Report of the Chief Planning Officer

PLANS PANEL EAST

Subject: APPLICATION 12/00113/FU – Demolition of existing hotel and erection of a foodstore with associated access, car parking, servicing and landscaping at site of Mercure Hotel, Leeds Road, Wetherby LS22

POSITION STATEMENT:

PROJECT: **PROPOSED SITE PLAN**

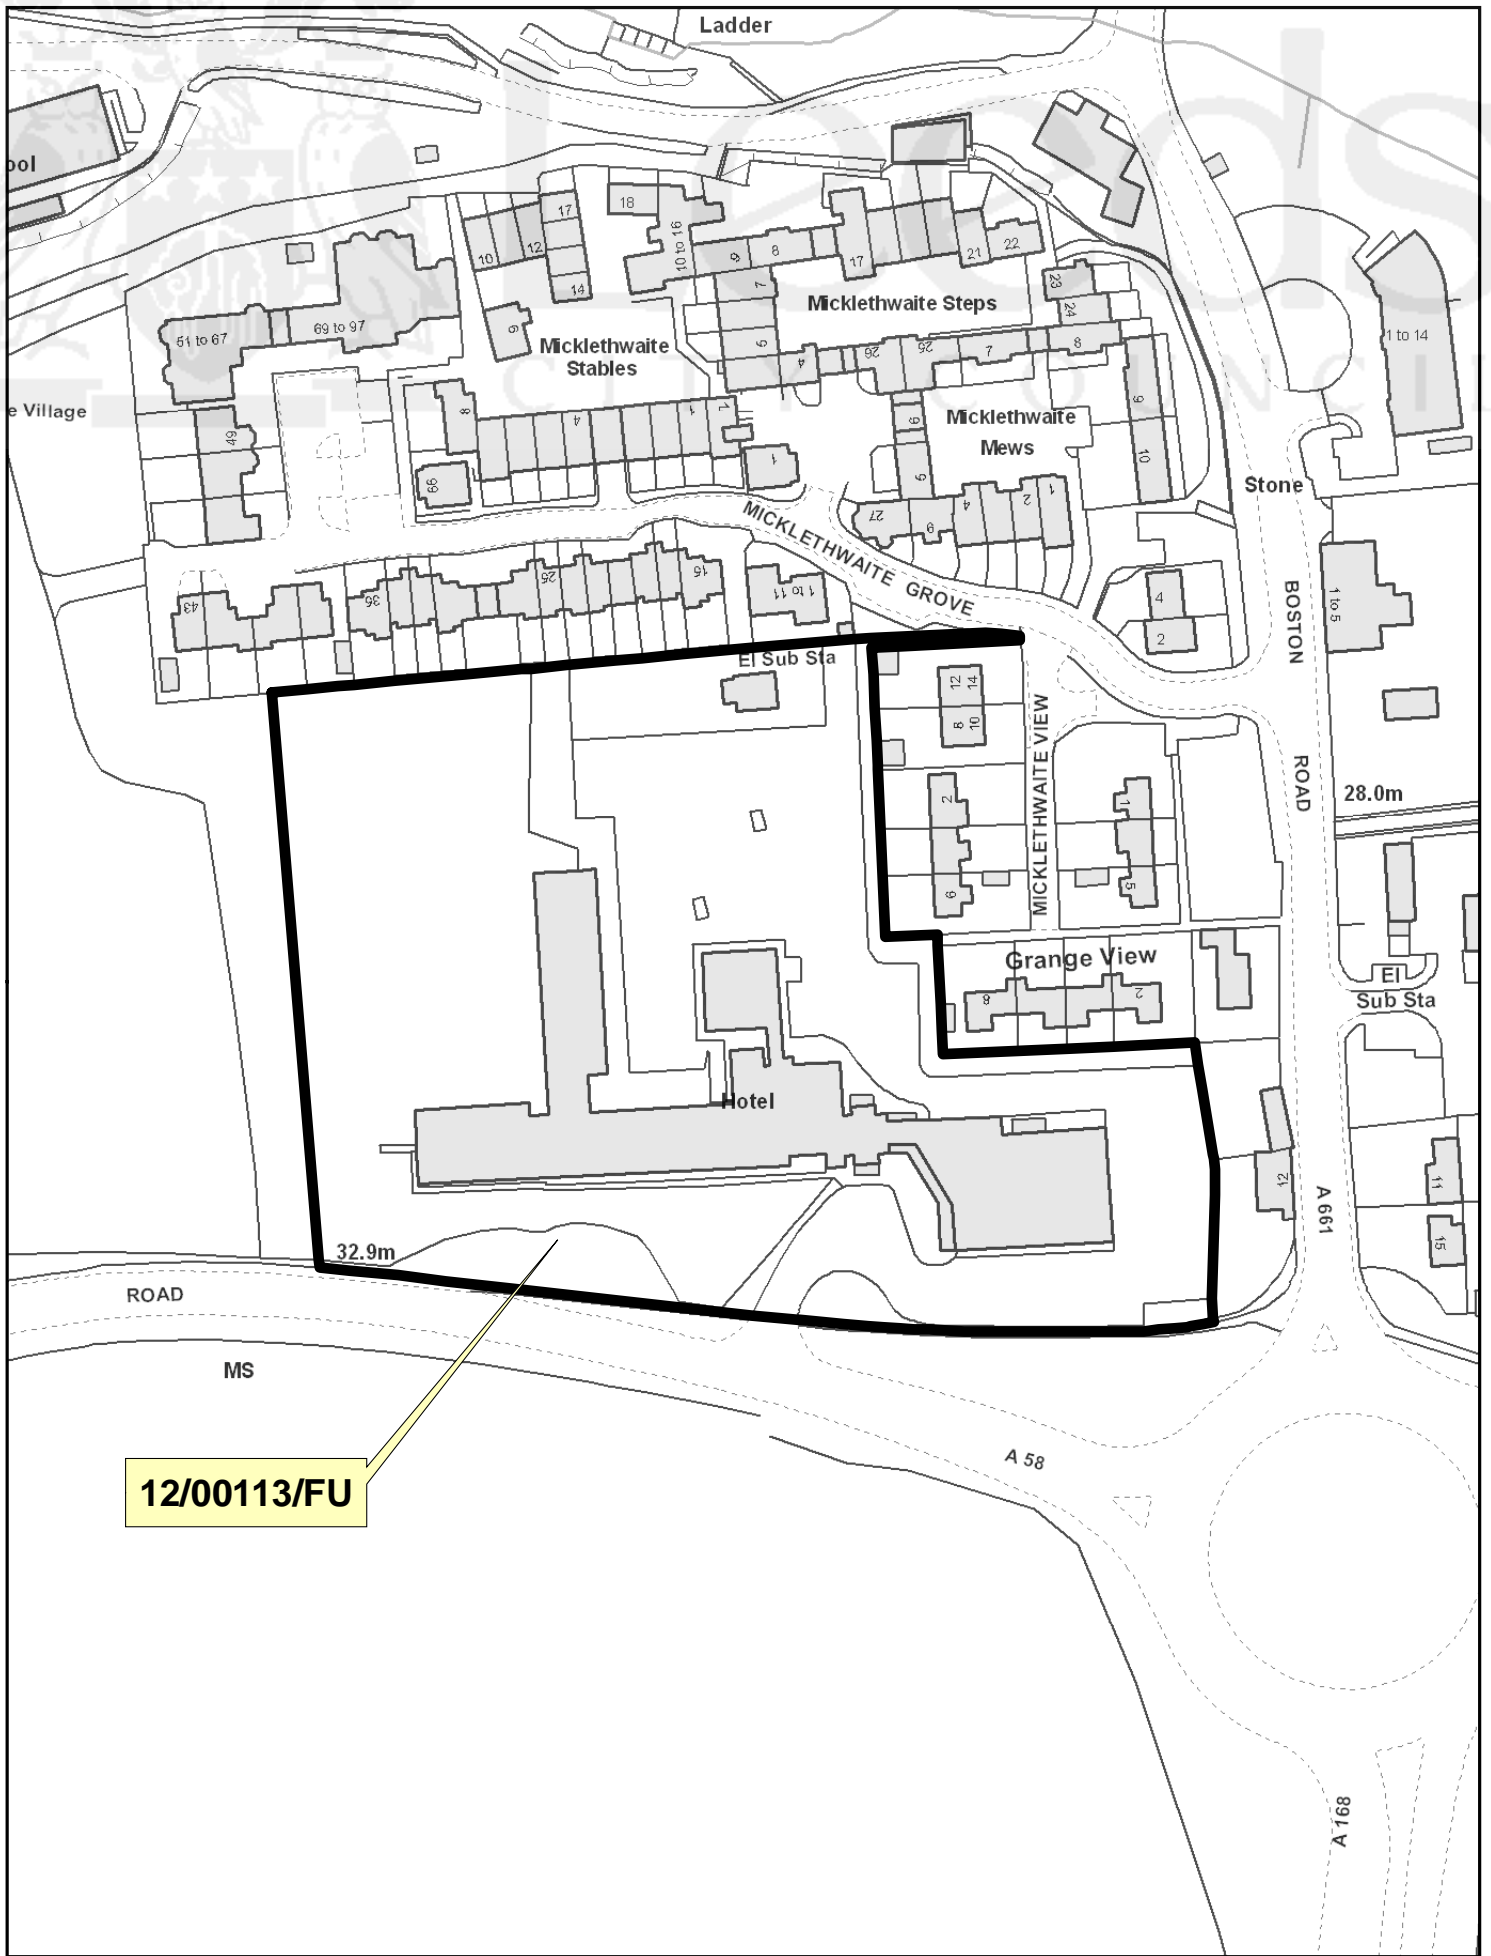
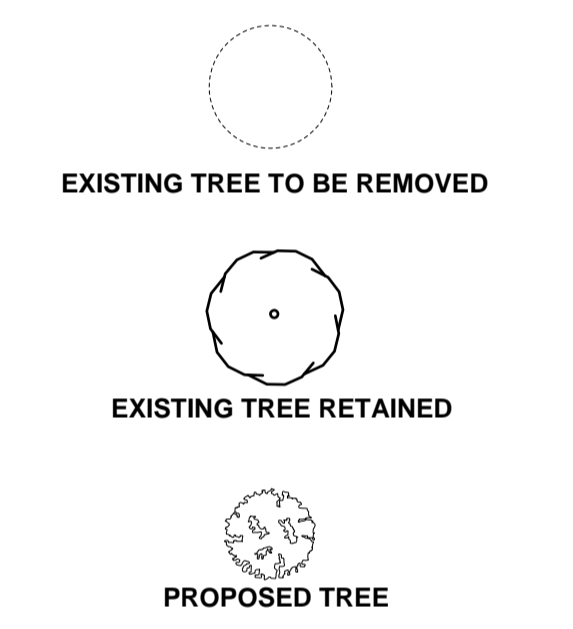
7.8 The proximity of the service yard to Wetherby Road is unacceptable as submitted and is likely to result in problems with any delay in vehicles gaining access to the yard or two service vehicles arriving at the same time causing vehicles backing up onto Wetherby Road which is a strategic route classified as the A58. Tracking is not provided to show that two vehicles can operate within the yard at the same time. The exit from the yard is also of concern and could cause problems with vehicles accessing the car park.

- 10.18 The scheme has been considered by the Design Review Panel where it was considered that the siting of the building is forced into a corner and the edges of the site are not treated appropriately. The scheme relies on off site planting on highway land to the south along Wetherby Road and from third party land to the east.

- 10.35 The application proposes to site the building onto part of the site which is currently grassed and open. There will therefore clearly be a change in terms of the relationship of residential properties on Micklethwaite Grove with the site. The proposed store building will be sited some 8.5m from the boundary with rear gardens. Planting is proposed in this strip of land as a buffer between the residential properties and the store. The proposed building will be set down by approximately 1.3m below the level of the gardens. The resultant relationship will therefore be a building height of 5.5m at a distance of 19.5m from the rear of No's 23 – 39 Micklethwaite Grove and 8.5m away from rear garden boundaries. Planting is proposed to screen the side/ blank elevation of the store from the outlook of these residential properties either from habitable room windows or from within the gardens.

- 10.42 **Members are asked to comment on the relationship of the proposed supermarket and car parking to residential properties.**
